Project Name: Spot Bar
Project Address: 859 Randolph Avenue
Suite #/Campus: N/A
City Name: St. Paul
Applicant: Bruce Pastorius, Collective Carpentry

SPOT BAR	OUTDOOR LOUNGE
859 RANDOLPH AVE	8'X19' DECK
ST. PAUL MN 55102	10'X30' DECK
MERIDITH O'DOLE	37 LF PRIVACY FENCE
	P.I

CITY OF ST. PAUL	
REVIEWED FOR CODE COMPLIANCE	
ARCHITECTURAL	V-21-2094
DATE	12/13/2021 MD
STRUCTURAL	
DATE

REVISED PLAN 12/20/2021:
REDUCED SIZE OF PROPOSED
DECK TO 20' x 20'

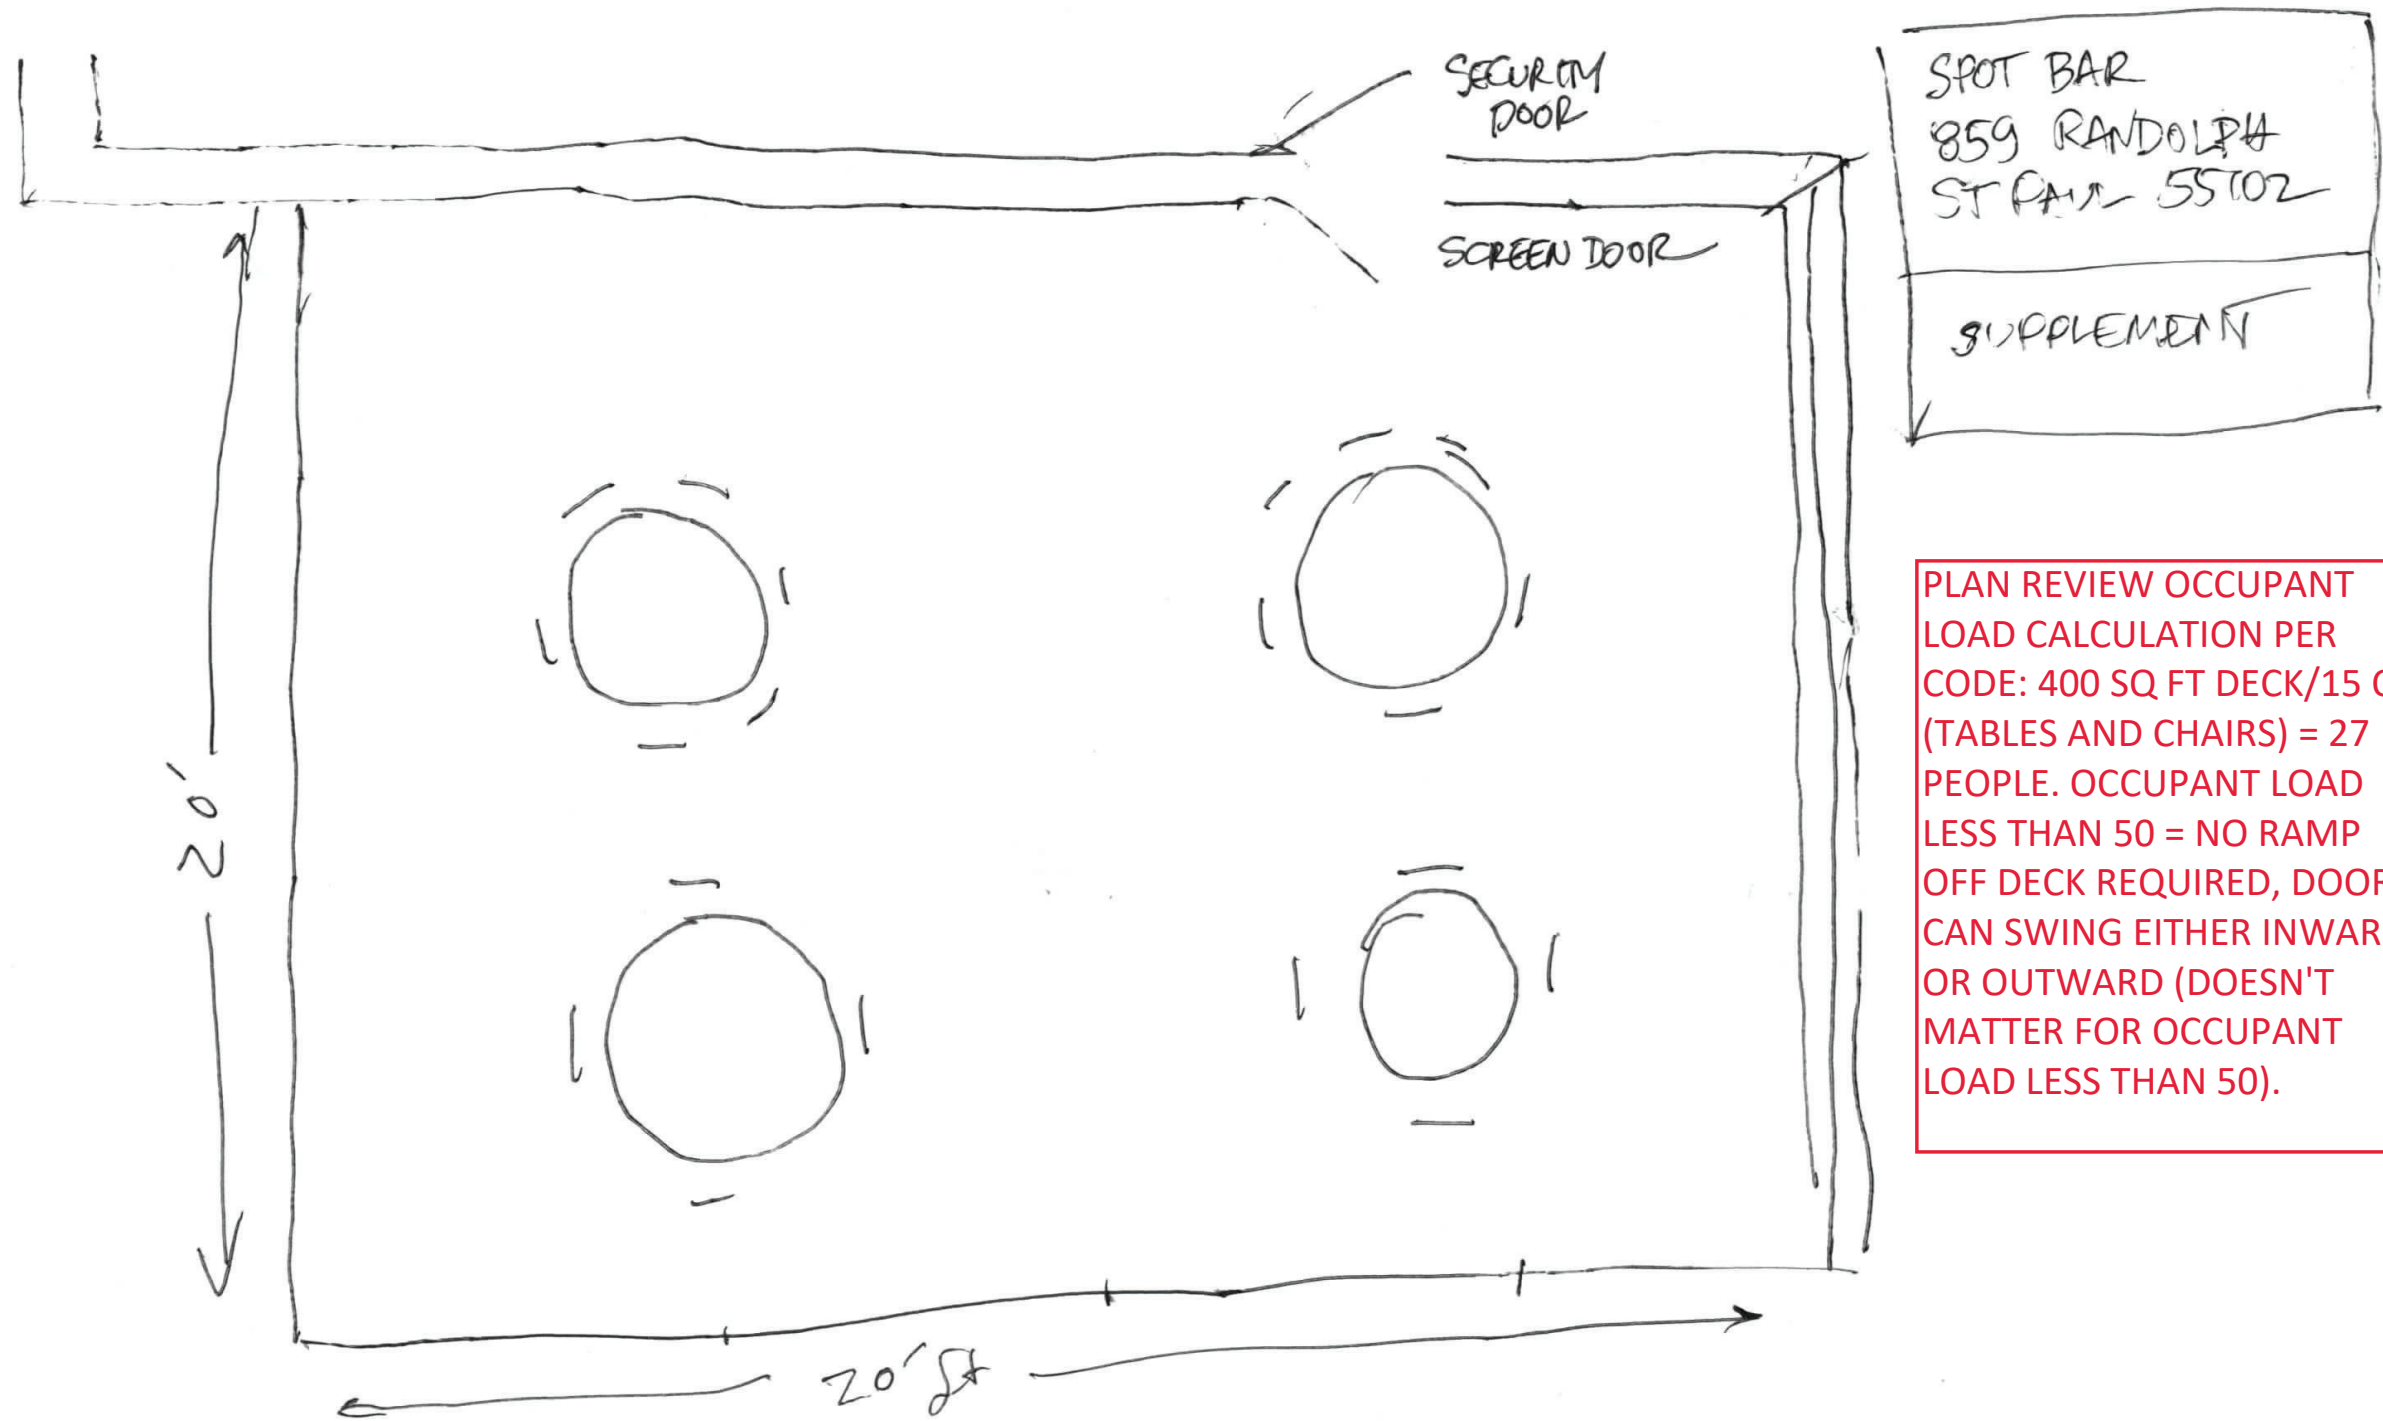
FENCE/RAILING TO ENCLOSE ENTIRE DECK AND BE ATTACHED TO DECK

PLAN REVIEW OCCUPANT
LOAD CALCULATION PER
CODE: 400 SQ FT DECK/15 OL
(TABLES AND CHAIRS) = 27
PEOPLE. OCCUPANT LOAD
LESS THAN 50 = NO RAMP
OFF DECK REQUIRED, DOOR
CAN SWING EITHER INWARD
OR OUTWARD (DOESN'T
MATTER FOR OCCUPANT
LOAD LESS THAN 50).
